REVISED DIRECT TESTIMONY

GREG ROCKROHR

Ameren Transmission Company of Illinois

DOCKET NO. 14-0514

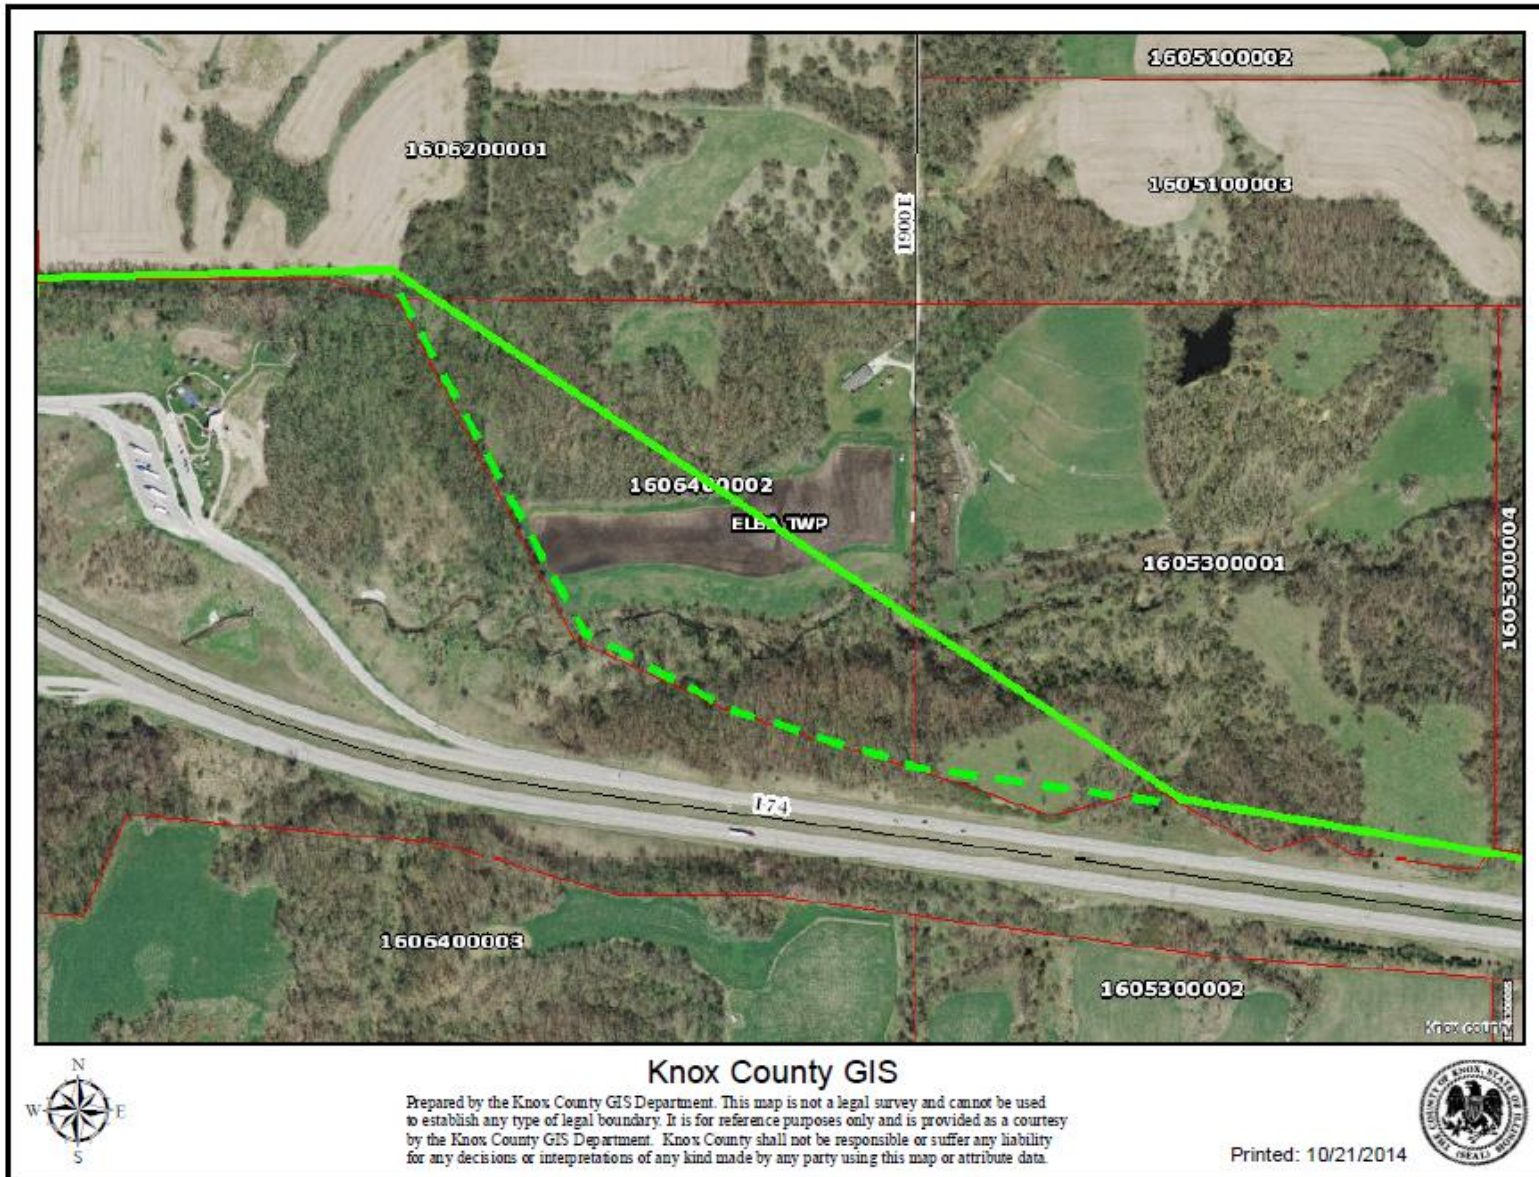
240 The green dashed line shown on Attachment B illustrates my first suggested
241 modification.¹⁶ Route A, as proposed by ATXI (solid green line on Attachment B),
242 appears to pass diagonally through the center of a parcel and tilled field that is east
243 of, and adjacent to, a rest area along I-74. It also appears to me to be closer to a
244 residence on that parcel than is necessary. I suggest that ATXI instead continue
245 to parallel the edge of the I-74 right-of-way, including the right of way associated
246 with the I-74 rest area. I recognize that additional angle structures may be required
247 to construct this modification, and recommend that, in rebuttal testimony, ATXI
248 provide an estimate of the additional dollar cost, if any, associated with using it.

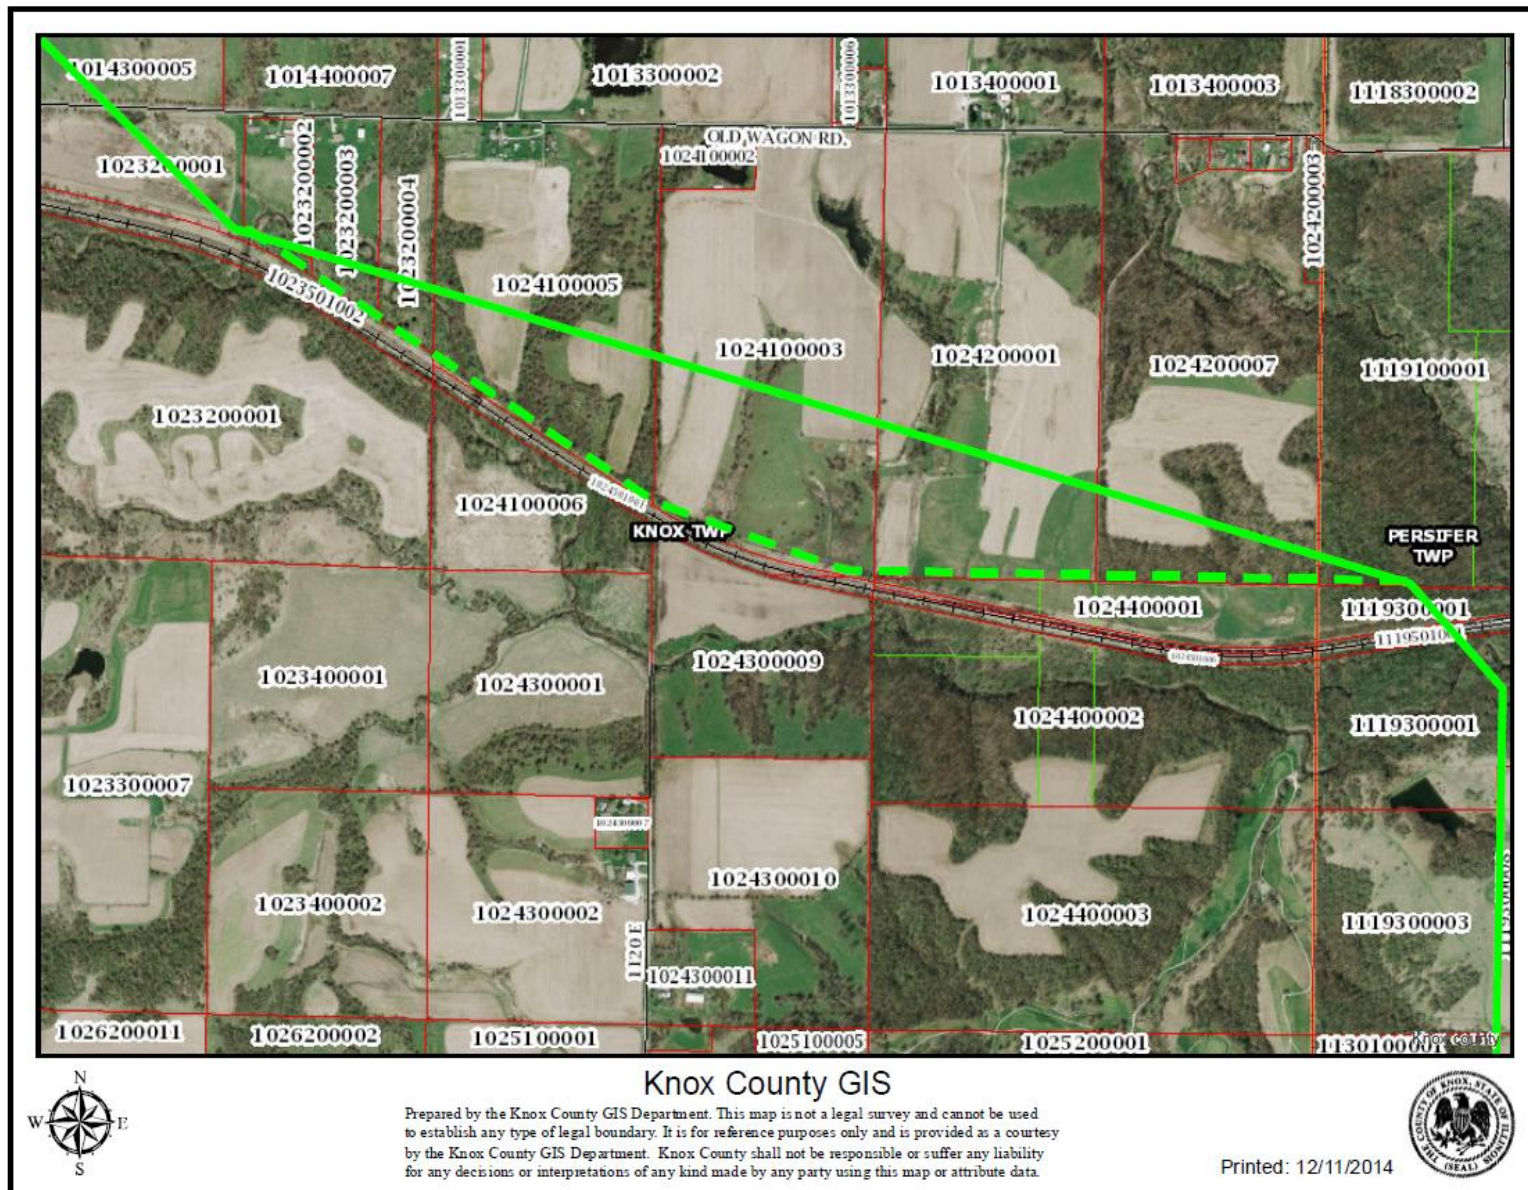
249 The green dashed line shown on Attachment C illustrates my second suggested
250 modification.¹⁷ Rather than cutting across tilled fields, as ATXI’s Route A does
251 (solid green line), I suggest ATXI move its route further south, still on the same
252 parcels, but parallel to the southern property lines. Again, the modification I
253 propose affects the number and type of angle structures. It is also my
254 understanding that placing the 345 kV line parallel to a railroad for short distance,

as I suggest, may or may not result in additional costs due to the railroad's need to place additional grounding on its facilities. I recommend that ATXI, in rebuttal testimony, provide its estimate of any additional dollar cost that would result from using my suggested route modification.
